# Development Management Sub Committee

**Application for Planning Permission 13/01342/FUL  
At Land At, Greendykes Road, Edinburgh  
Residential development comprising 145 private residential  
units, part of Greendykes Masterplan Site areas C and D  
associated with planning application reference  
12/01109/AMC.**

Item number	6.4
Report number	
Wards	A17 - Portobello/Craigmillar

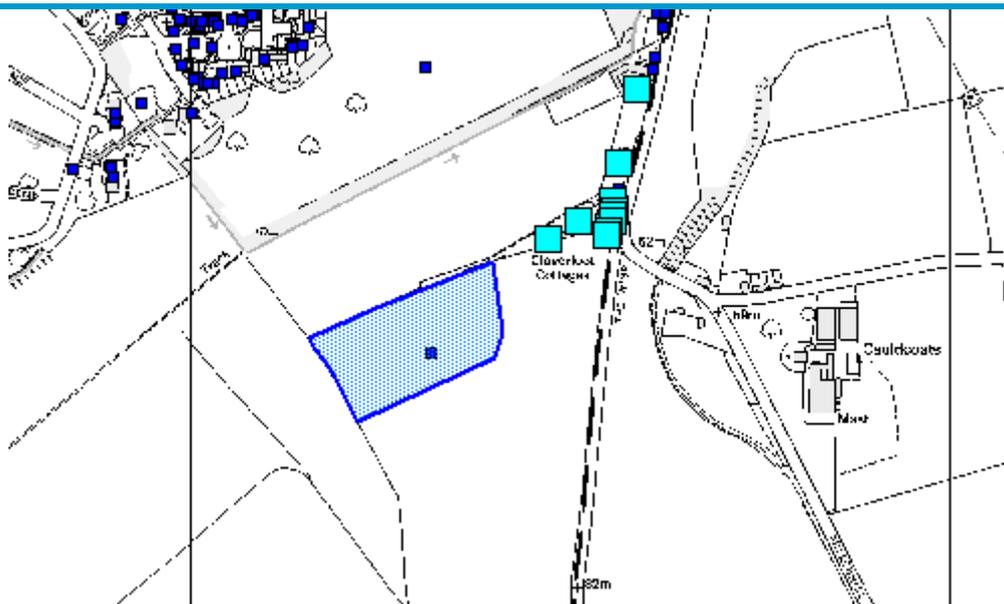
5.1 *Residents in the local Wisp area have recently raised concerns about changes to the flow regime in the Magdalene Burn (the relatively small watercourse which is shown to the east of the 'Key Site Junction' shown on the map on page 4 of the site's 'Design Statement' as a result of enabling works immediately to the west of the burn.*

*This appears to have resulted in flows which previously discharged to the burn being re-directed to the new Niddrie Burn. Residents have concerns over a lack of dilution being available for septic tanks and over increased flood risk as a result of silt deposition due to reduced flows. We would highlight the benefits of SEPA/City of Edinburgh Council and developers working together to undertake an assessment of what flows could reasonably be expected in the Magdalene Burn, and ensure that site drainage be directed appropriately to ensure that any impact on flows is addressed.*
